From: Howard, Leslie Ann CIV USN BRAC PMO SAN CA (USA)
Sent: Thursday, January 21, 2021 12:53 PM
To: Ueno, Karen <Ueno.Karen@epa.gov>; Bacey, Juanita@DTSC <Juanita.Bacey@dtsc.ca.gov>; White, Jeff@Waterboards <Jeff.White@Waterboards.ca.gov>; Low, Tina@Waterboards <Tina.Low@waterboards.ca.gov>; Brownell, Amy (DPH) <amy.brownell@sfdph.org>; Chesnutt, John <Chesnutt.John@epa.gov>; King, Nathan@Waterboards <Nathan.King@waterboards.ca.gov>
Cc: Robinson, Derek J CIV USN NAVFAC SW SAN CA (USA) <derek.j.robinson1@navy.mil>; Pauly, Brooks CIV USN BRAC PMO SAN CA (USA) <brooks.pauly@navy.mil>; Egan, Jamie <Jamie.Egan@jacobs.com>; Macchiarella, Thomas L CIV USN COMNAVFACENGCOM DC (USA) <thomas.macchiarella@navy.mil>
Subject: HPNS Parcel E-2 Phase II Draft Final RACSR

APPENDIX A RESPONSE TO AGENCY COMMENTS

Response to Comments on the Draft *[Final]* Remedial Action Construction Summary Report, Parcel E-2 Phase II, Hunters Point Naval Shipyard, San Francisco, California, June 2020, DCN: APTM-2005-0013-0047

PUBLIC WORKS PROGRAM FY 1958

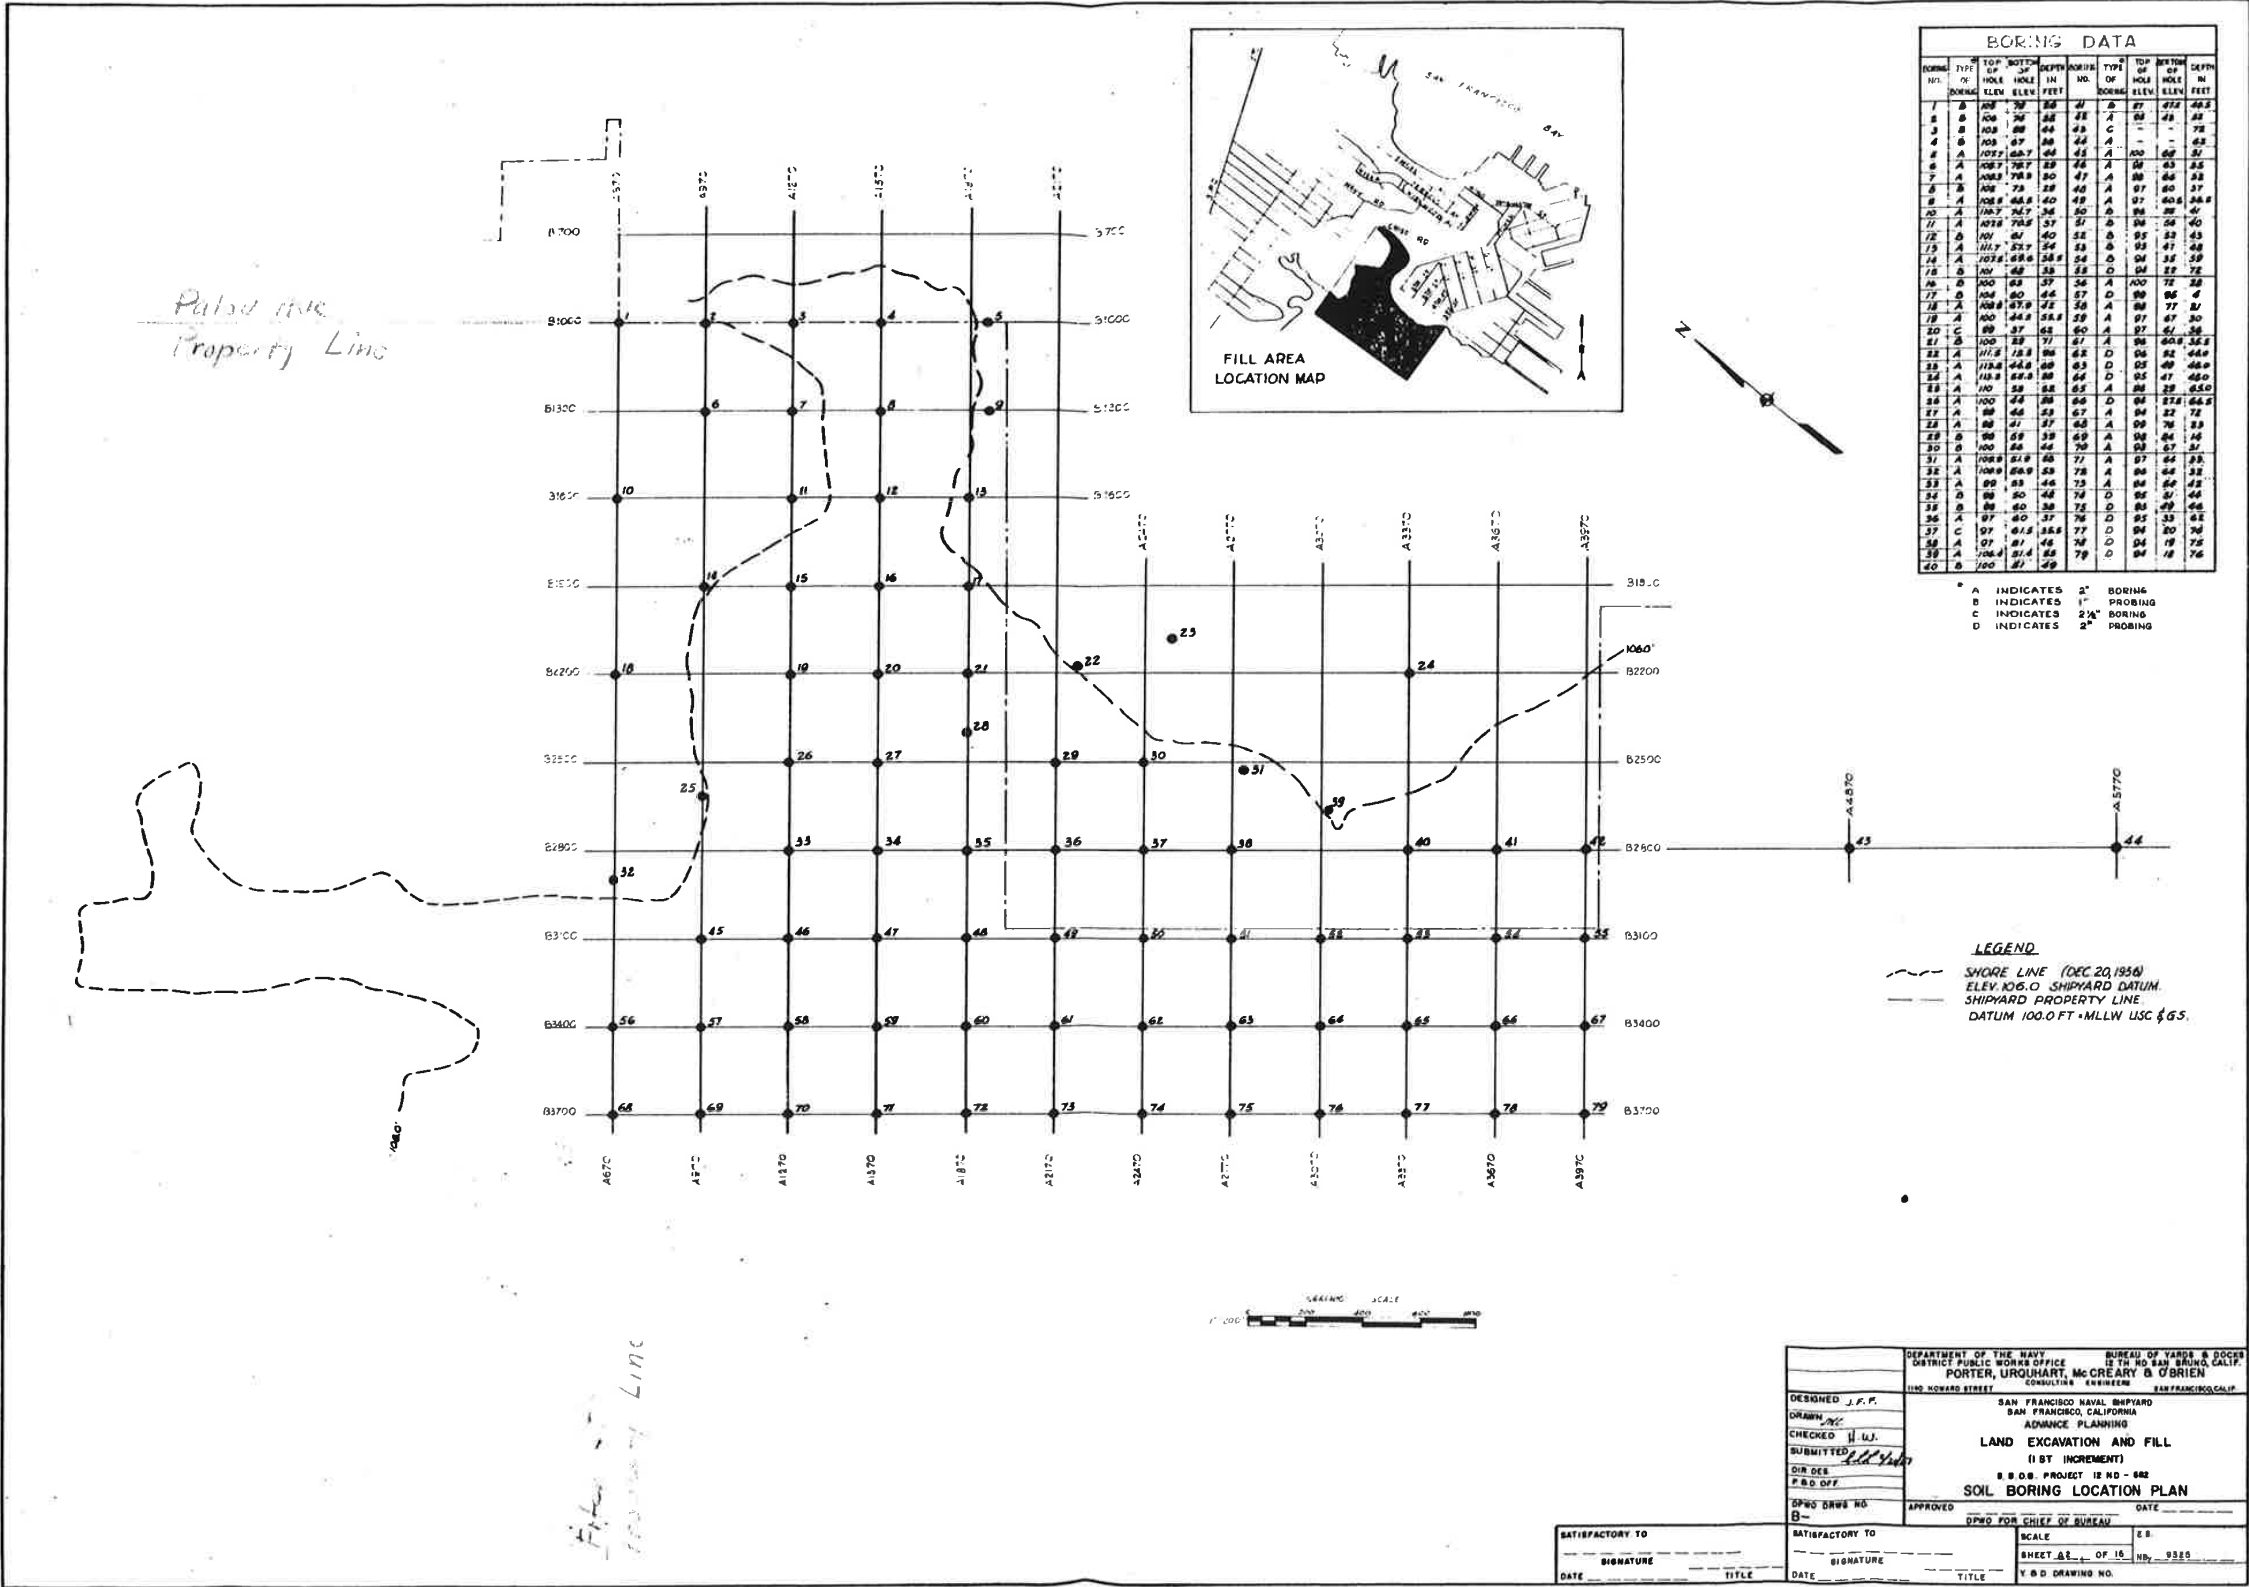
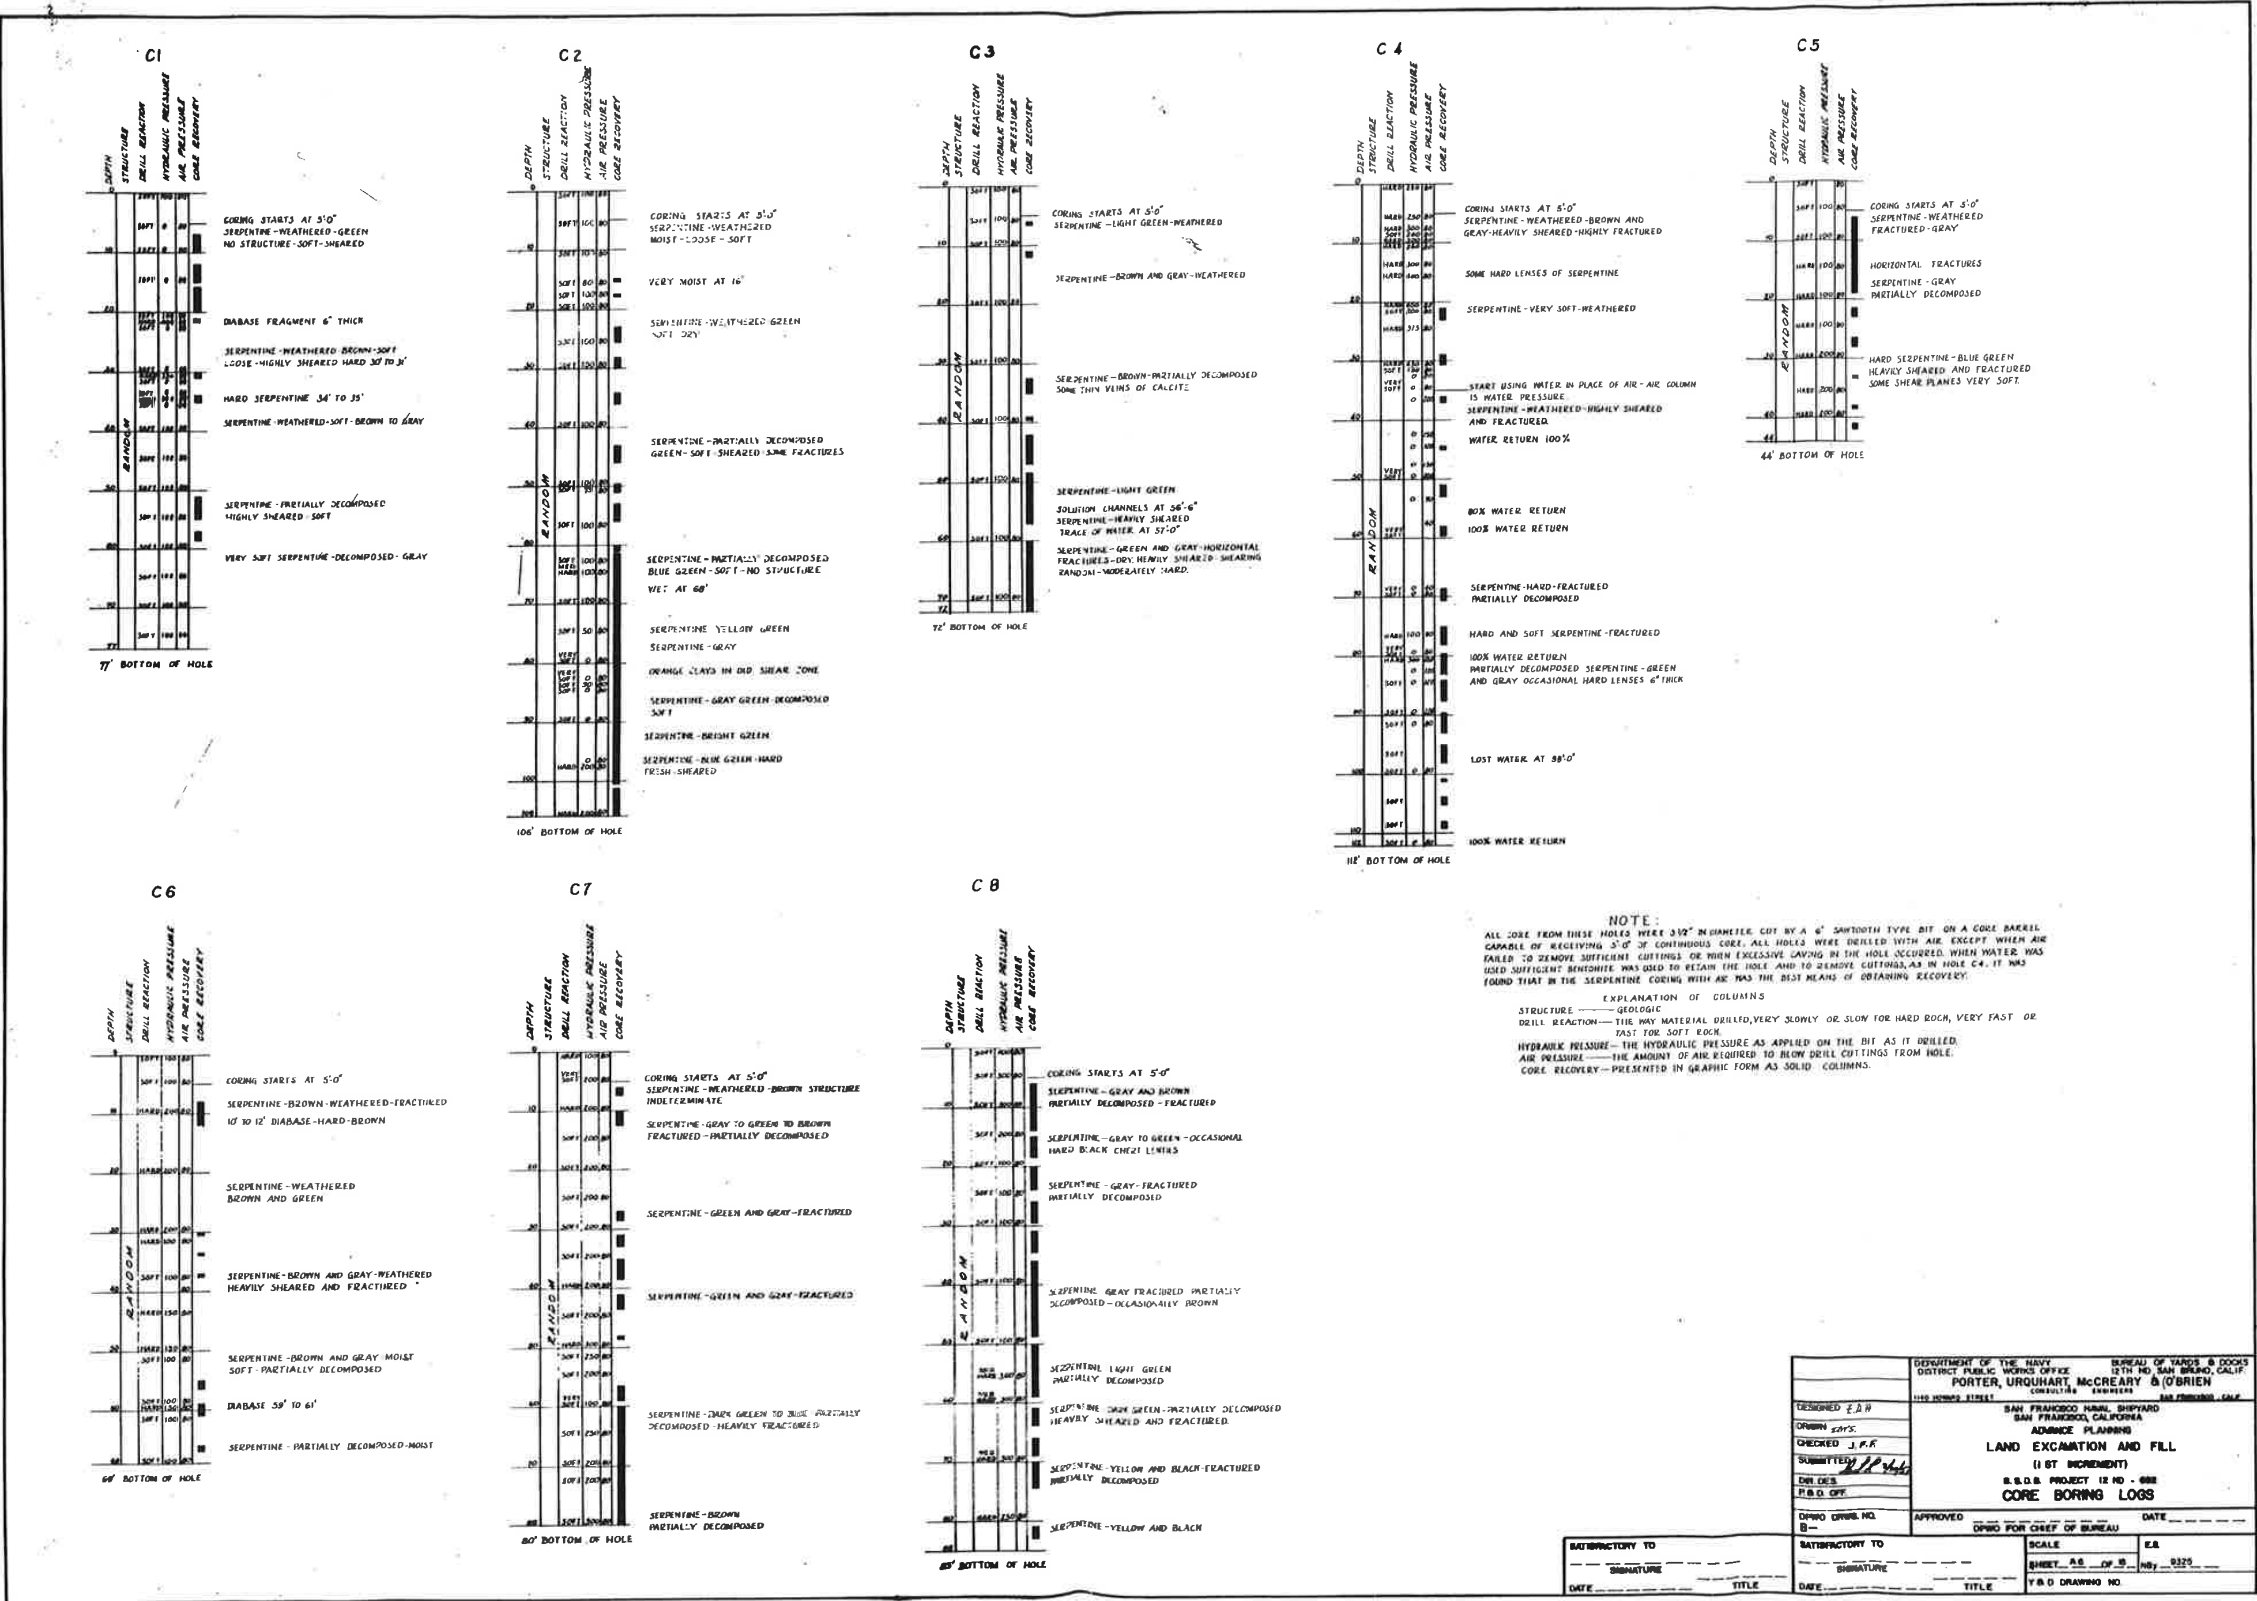
<p>3. Section 4.2 Upland Slurry Wall and French Drain The second sentence in the third paragraph states that information collected during installation of the slurry wall together with a historical record search indicates that the obstruction encountered at a depth of about ten feet along an approximate 200-foot section of the slurry wall alignment is geologic rather than man-made. The sentence further states that Aptim recommends leaving the slurry wall as constructed without further alterations to the target depth. However, we note that the text does not discuss the field data and nature of any samples obtained to support the geologic nature of the obstruction or how the requirement to key in the slurry wall into the underlying bay mud was met. The text should be revised to include a discussion of the field sampling data/information and the effect of terminating the slurry wall on top of/within the obstruction and whether/how this termination meets the approved design.</p>	<p>As described in the final paragraph of Section 3.2.14, the upland slurry wall is considered a “hanging” slurry wall because it was not intended to key into an aquitard. A two-foot key into the underlying bay mud layer was only a requirement for the nearshore slurry wall which was installed by a previous contractor in 2016. As discussed within the final DBR, some groundwater will flow under the upland slurry wall, but groundwater modeling predictions (DBR Appendix F; ERRG. 2014) indicate that upgradient flow will mostly be diverted around the upland slurry wall or diverted to the freshwater wetland via the French drain (Section 3.2.14.7) installed on the upgradient side of the upland slurry wall. As described under Section 4.2, paragraph 2, of the Final RACSR (formerly RACR), a Direct Push rig was used in an attempt to map a path around the perceived obstruction. Unlike rotary drilling, drill cuttings were not removed from the hole, nor were geotechnical samples collected.</p>

[DTSC] No further comment on keying of the slurry wall into bay mud. However, no description of the obstruction material is included in the text. The second paragraph states that 12 step-out locations were investigated using a direct push drill rig to assess the obstruction in accordance with a recommendation from the Navy. The text states that difficult drilling conditions were encountered with six locations meeting complete refusal and six locations advancing to the design depth with difficulty. The text does not include any information on the material(s) encountered at any of the 12 locations. The text should be expanded to include a summary of the materials encountered at each of the 12 locations, or at the very least, the materials encountered at the six locations that were advanced to the design depth.

[October 23, 2020 Response] The RTC states that a Direct Push rig was used in an attempt to map a path around the perceived obstruction, but unlike rotary drilling, no drill cuttings were removed from the hole, nor were geotechnical samples collected. It appears that the method used was unsuitable for producing any useful information to determine the nature of the obstruction or whether the slurry wall was terminated properly over a distance of more than 200-feet, along the section located over the obstruction. We note that upland slurry wall specifications in the August 2014 Final Design Basis Report, Parcel E-2, Appendix C Project Specifications, Section 02 32 00 Subsurface Drilling, Sampling, and Testing 05/10, Part 1.6.2 Field Measurements states “For the upland slurry wall, it is the sole responsibility of the contractor to select the necessary boring spacing and frequency required to properly demonstrate that the bottom of the slurry wall is installed within the most impermeable material along the wall’s alignment”. In the absence of any information on the nature of the obstruction material (intact rock, weathered rock, gravel, cobble, etc.) or total depth of the obstruction it is not possible to determine if the above specification was met.

Please see response to Water Board comment #15. The rationale for the conclusion that this obstruction is bedrock is based on the historical boring logs as provided herein for review. The Navy will evaluate the Parcel E-2 RAMP (ERRG, 2014) and make revisions as necessary to ensure appropriate measures are put in place to adequately monitor the as-built effectiveness of both the upland and nearshore slurry wall systems.
